# Hitting the Target: ENERGY STAR SSL Outdoor Lighting Criteria

DOE Webcast  
October 8, 2009

## Presentation Overview

## Pole-Mounted 07/01/09 Draft Criteria

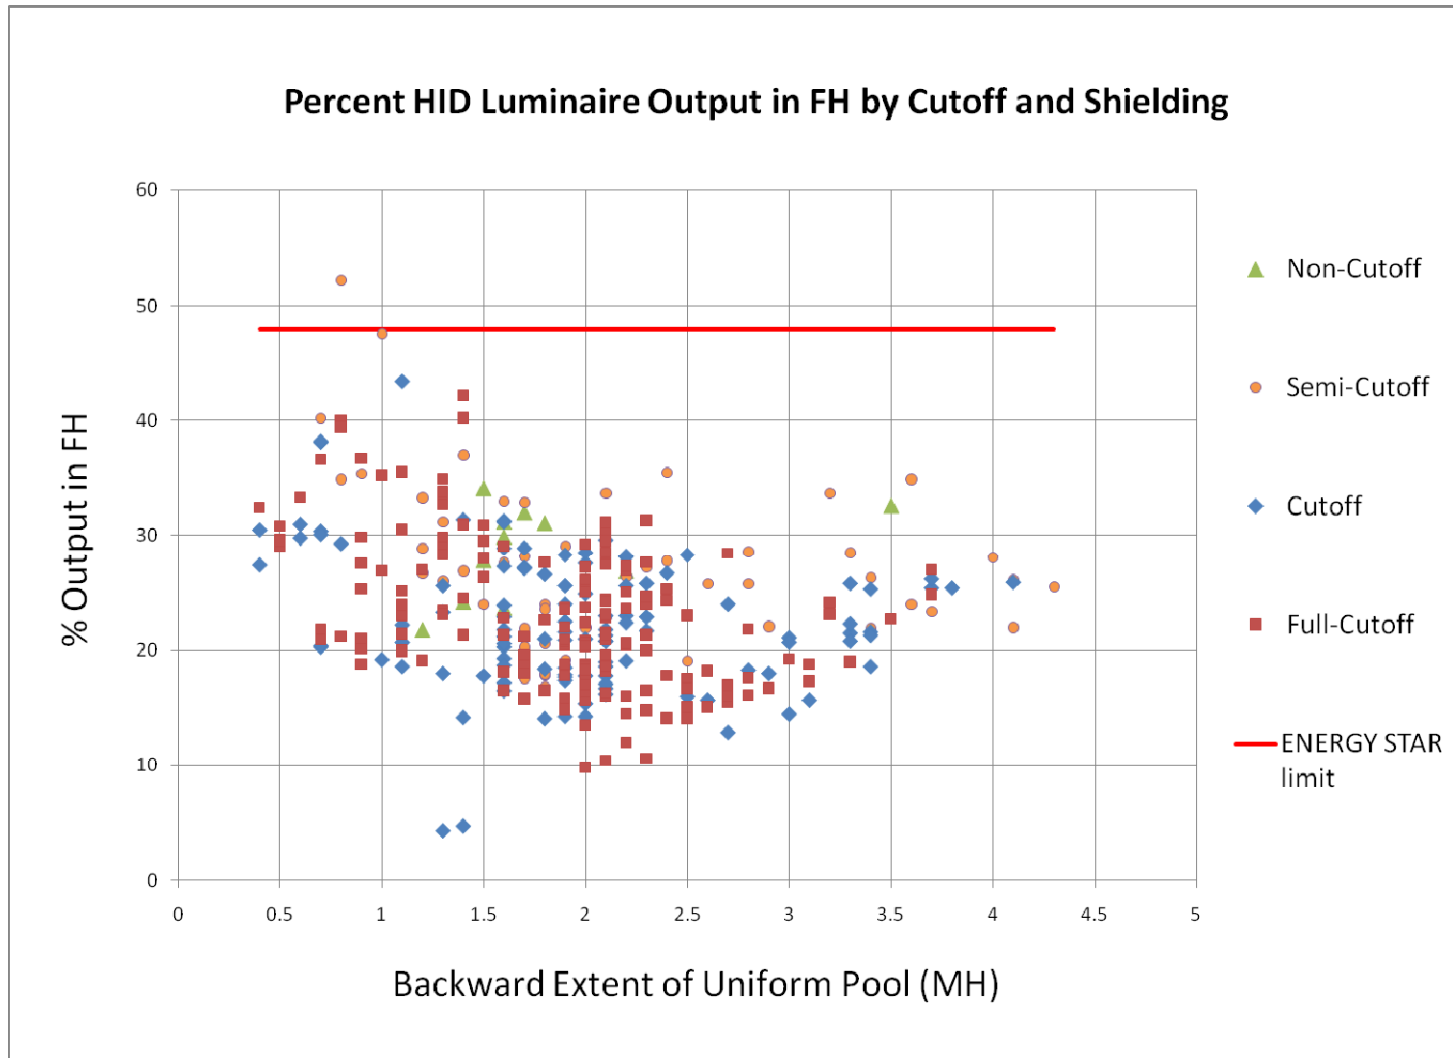
- Restrictions on FH, BH, FVH, and BVH lumens will discourage the use of high-performance luminaires.

- Restrictions on high-angle brightness don't affect LPD if wattage and spacing/MH are optimal. FVH and BVH were correlated to the old IES "cutoff" system. FH and BH were then scaled per BUG.

## Pole-Mounted 07/01/09 Draft Criteria

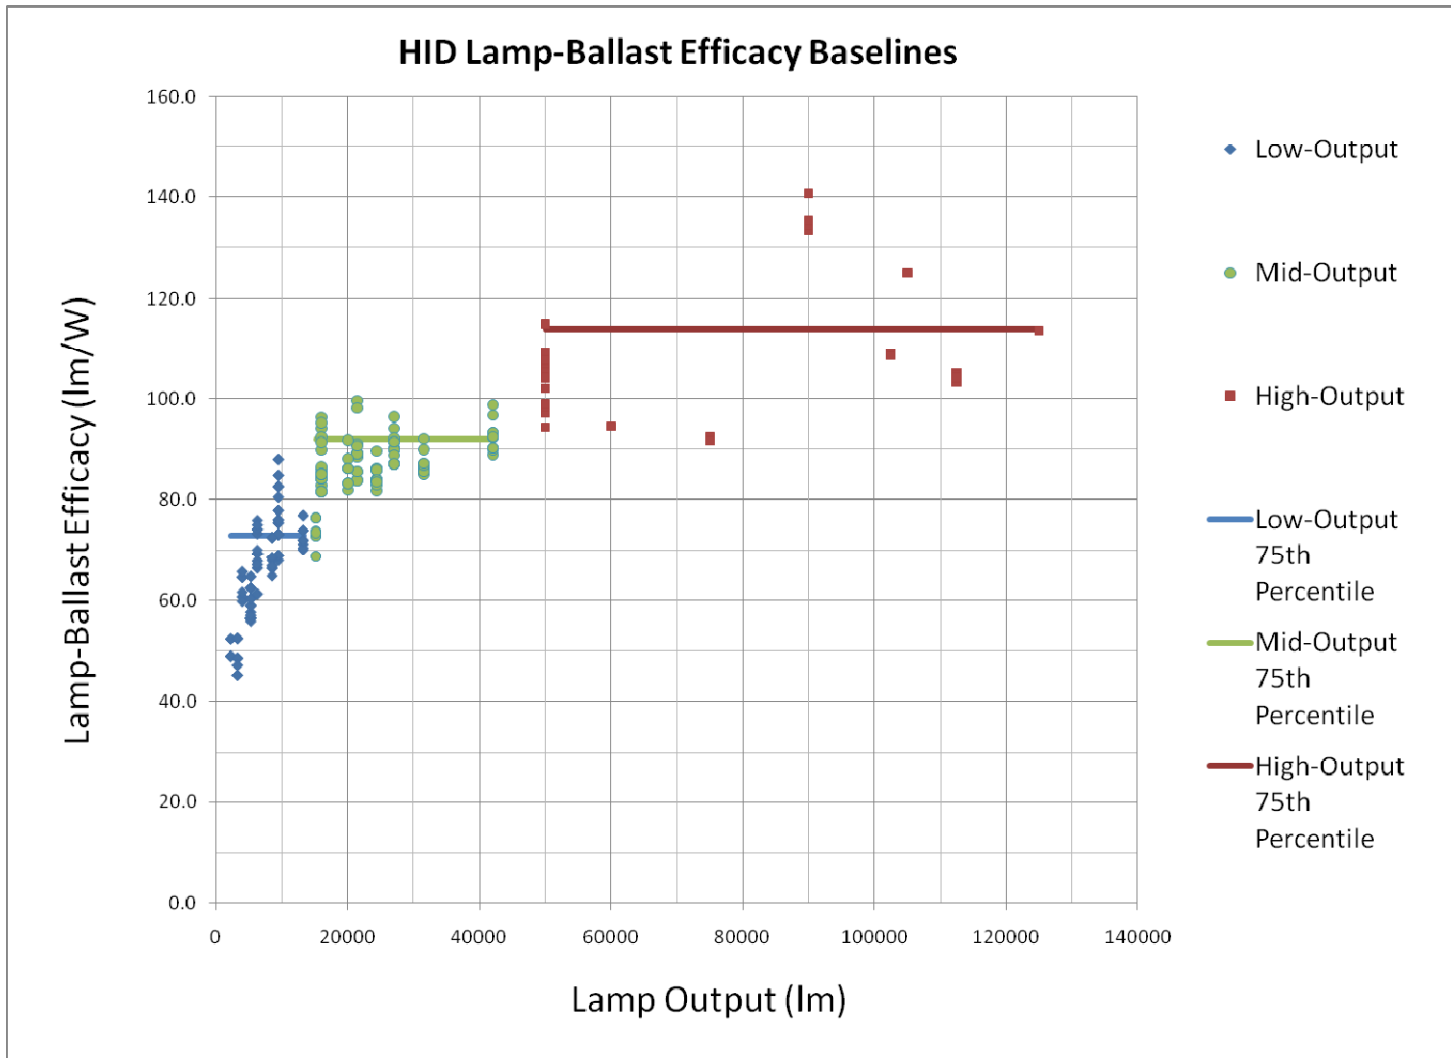
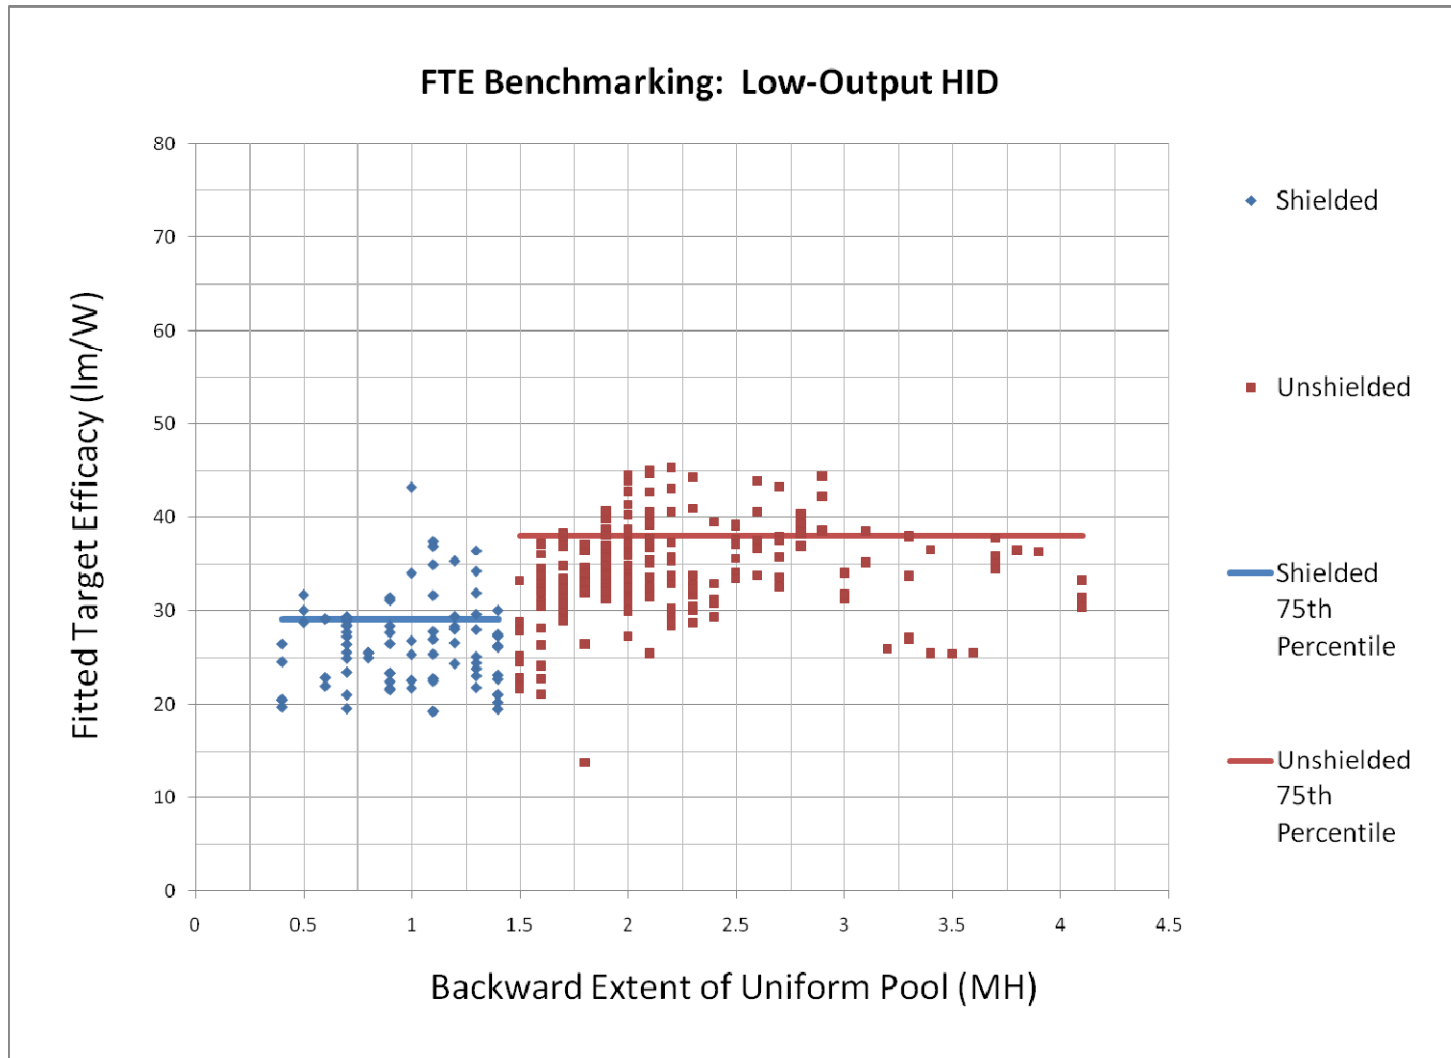
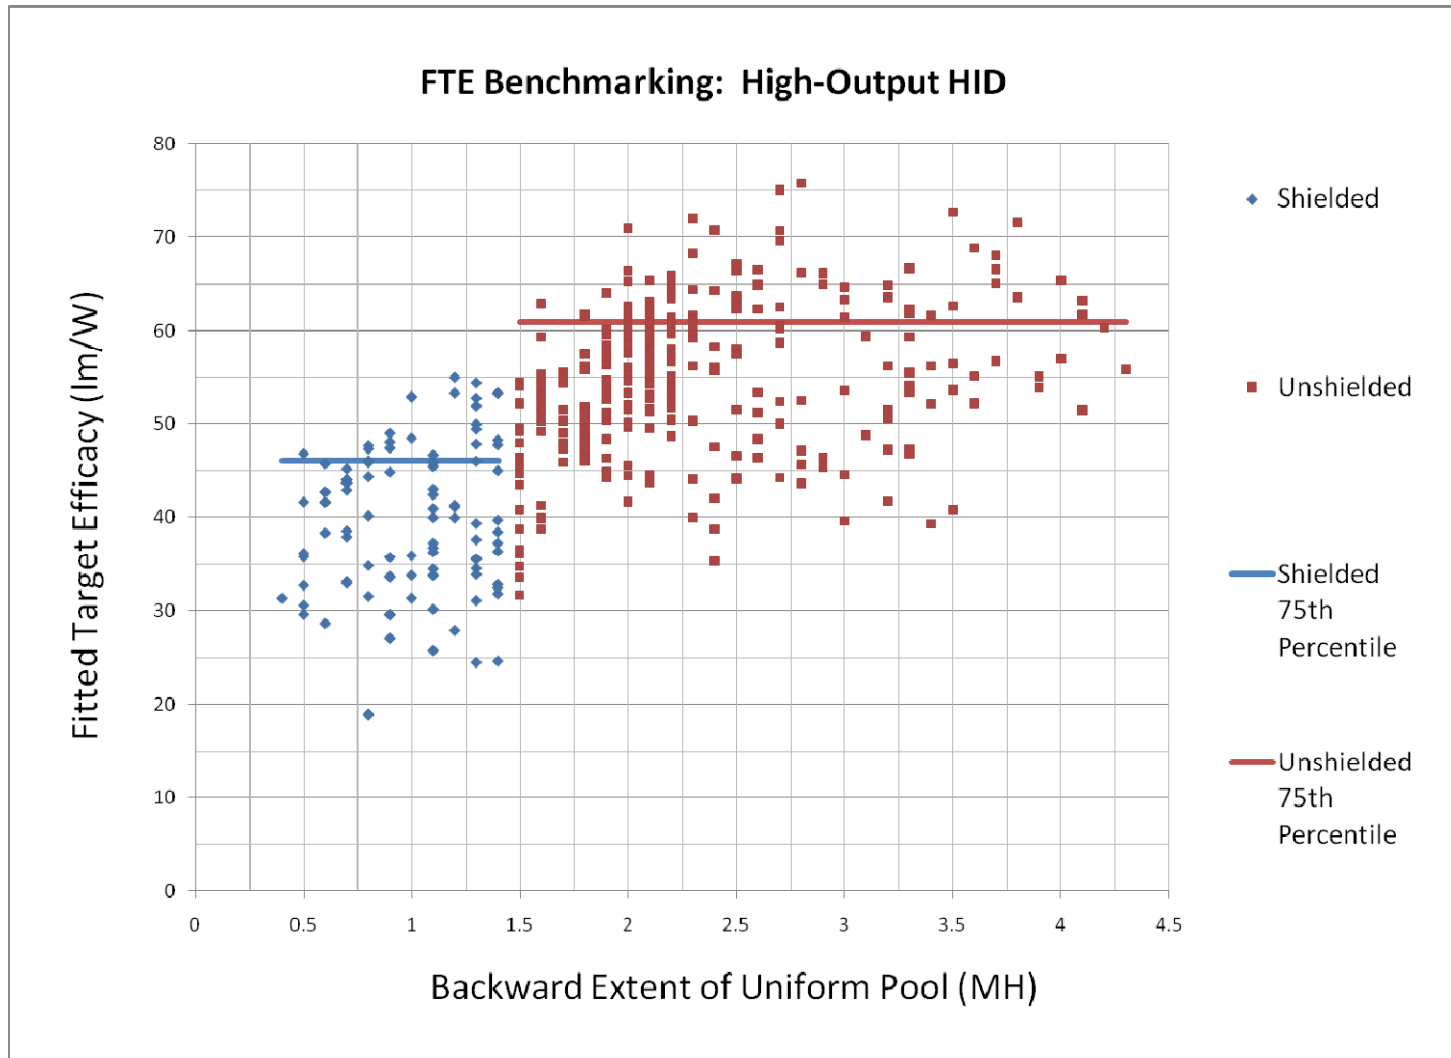
- It would be overly selective to expect LED to outperform 75<sup>th</sup> percentile HID by 20%.

- Requirements will be reduced to 75<sup>th</sup> percentile HID performance. Additionally, a Mid-Output category will be created.

## Pole-Mounted 07/01/09 Draft Criteria

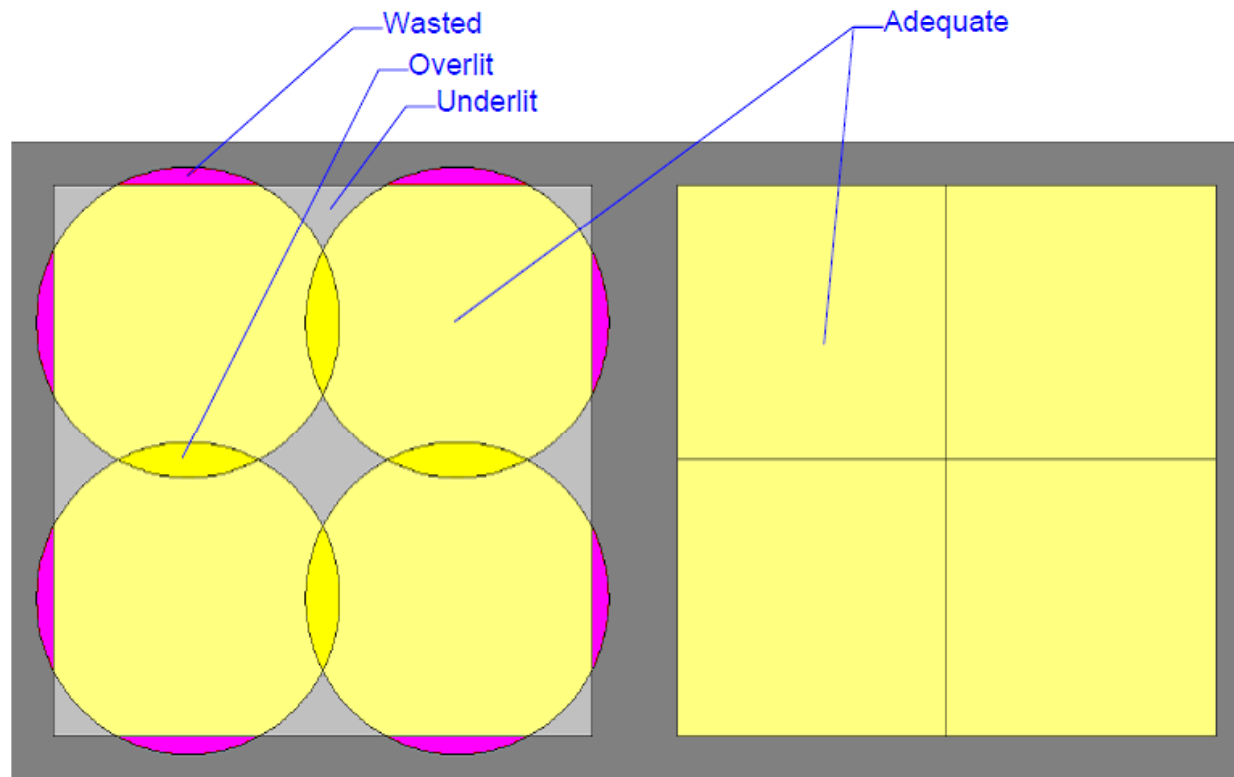
- Comment
  - The uniformity criteria are arbitrary, won't apply to every application, and will discard useful flux.
- Response
  - 6:1 avg:min is the most lenient criterion in IES RP-8 and correlates to 30:1 max:min for Uniform Pools produced by HID luminaires.

## Pole-Mounted 07/01/09 Draft Criteria

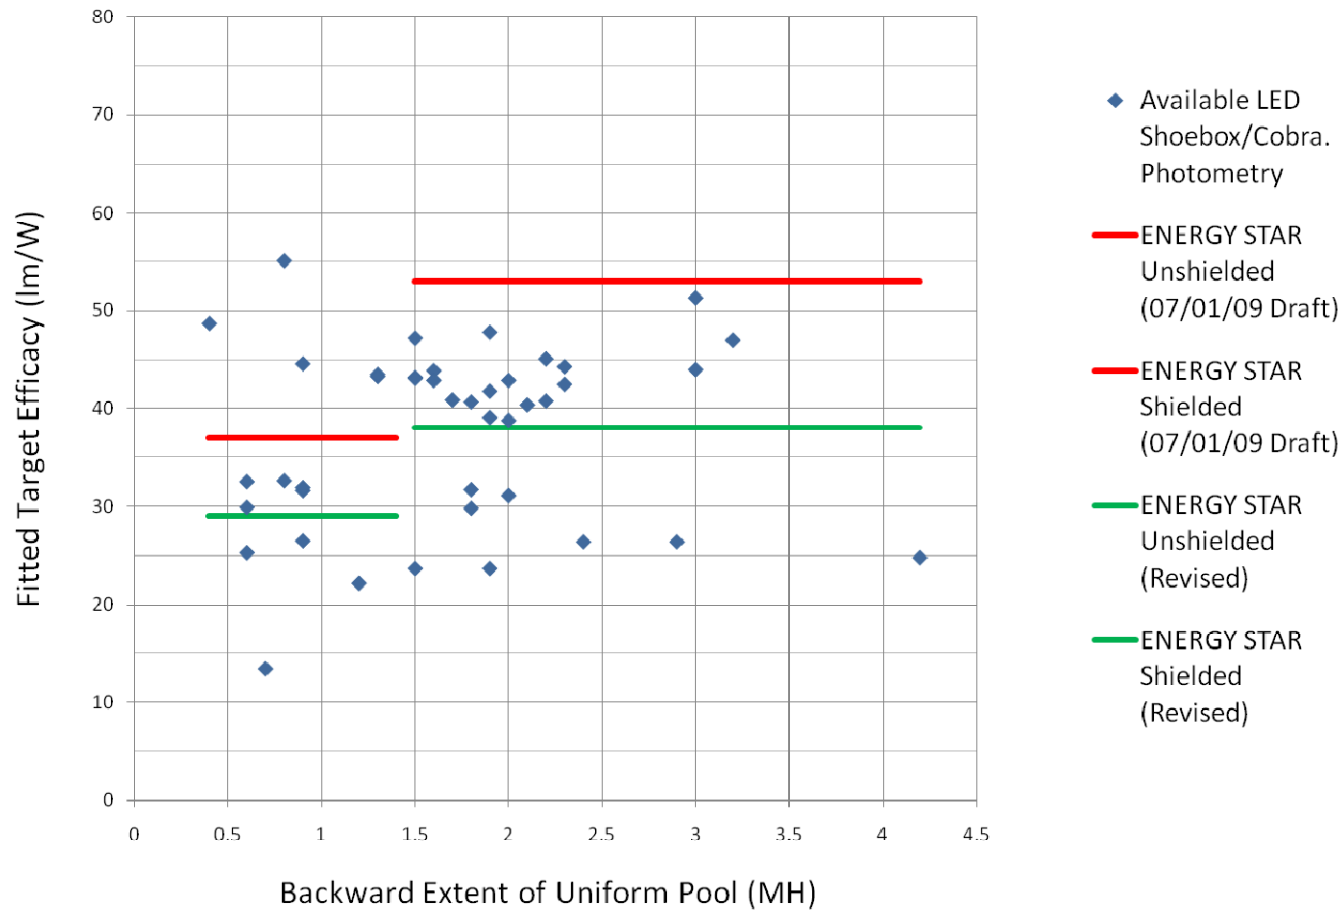
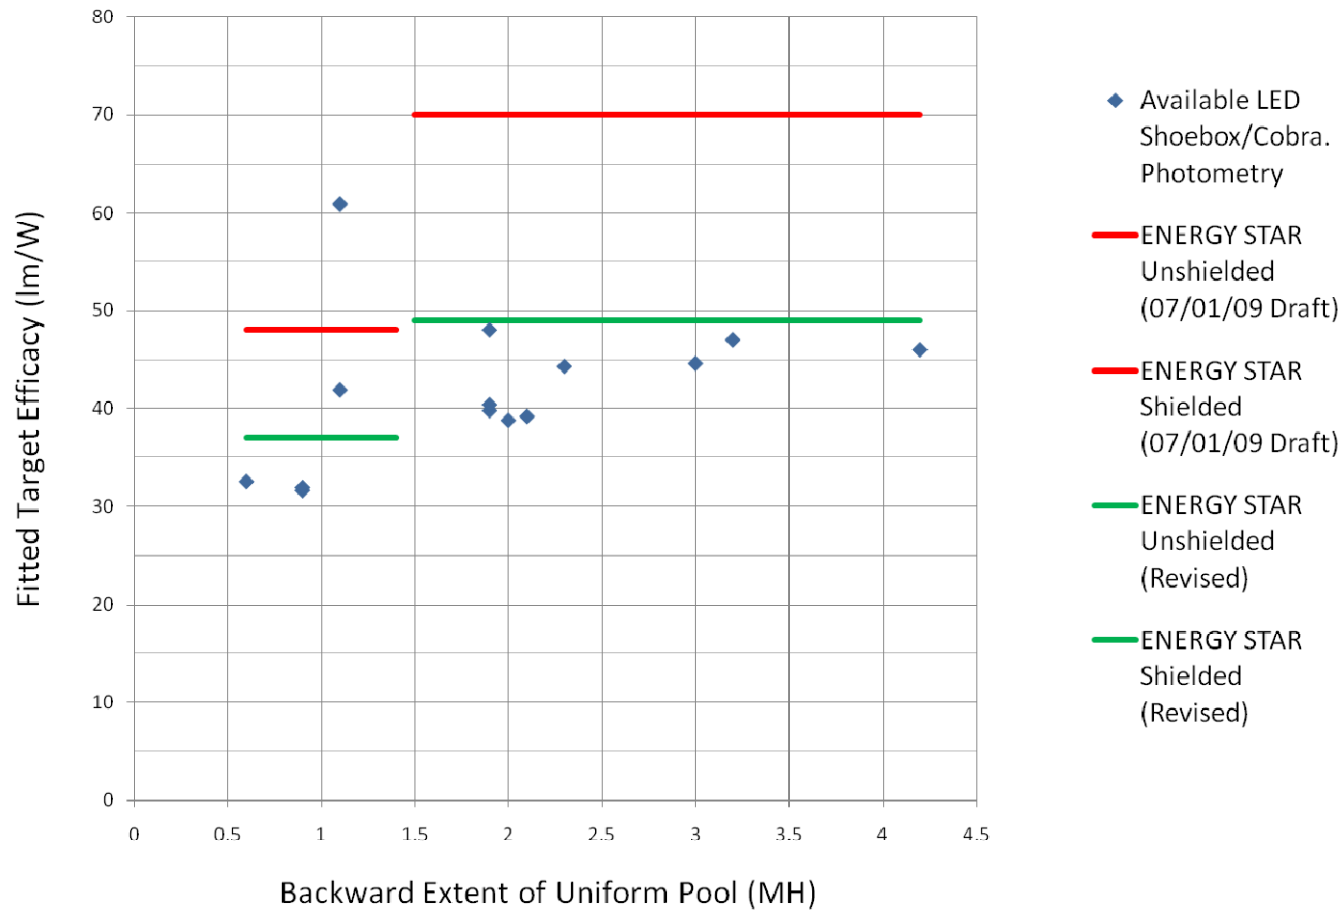
- Comment
  - High-Output and Unshielded luminaires are unfairly discouraged.
- Response
  - HID (baseline) efficacy improves with increased output and reduced shielding, so more stringent FTE requirements are appropriate for these categories.

- Baseline set at 75<sup>th</sup> percentile HID performance
  - No longer 20% savings over 75<sup>th</sup> percentile

## Pole-Mounted 07/01/09 Draft Criteria

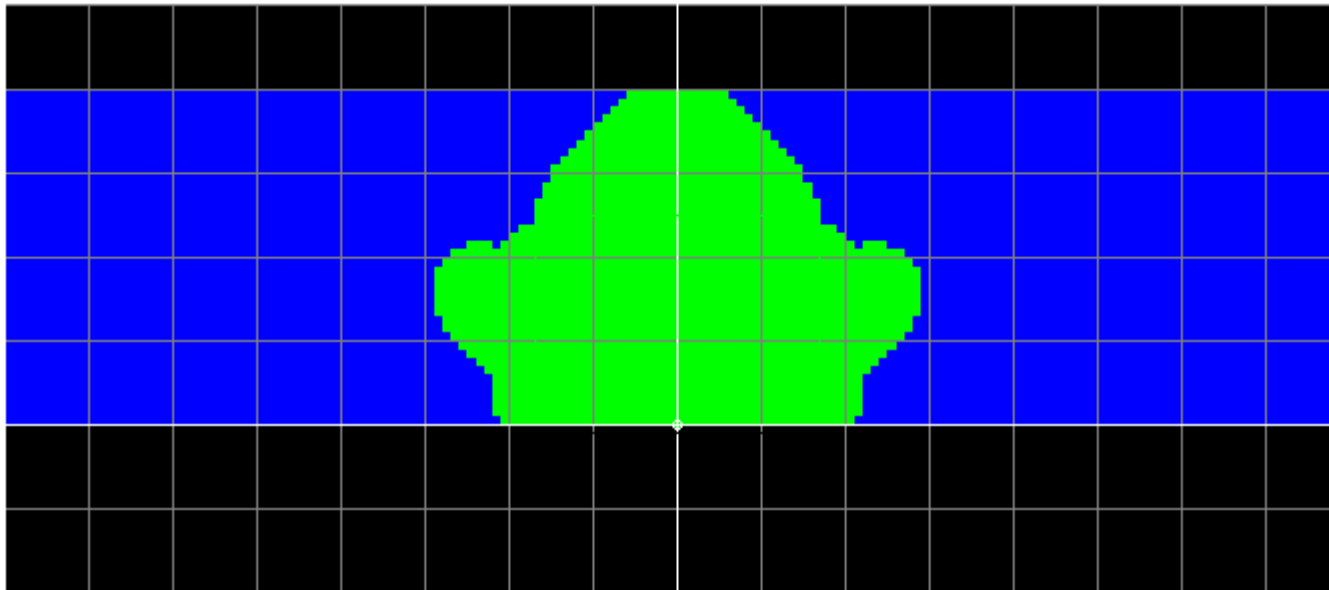
- Comment
  - Did you consider using Target Efficacy Rating (TER) as defined in NEMA LE 6-2008?
- Response

- Comment
  - Did you consider using Target Efficacy Rating (TER) as defined in NEMA LE 6-2008?
- Response
  - TER was evaluated but not adopted because neither uniformity nor shape of distribution are evaluated, and due to improper treatment of backlight.
  - A possible revision, to include backlight to 1.0-MH for Types **II-III-IV**, would be a major improvement.
    - ❖ Vote scheduled for 10/07/09 (yesterday).
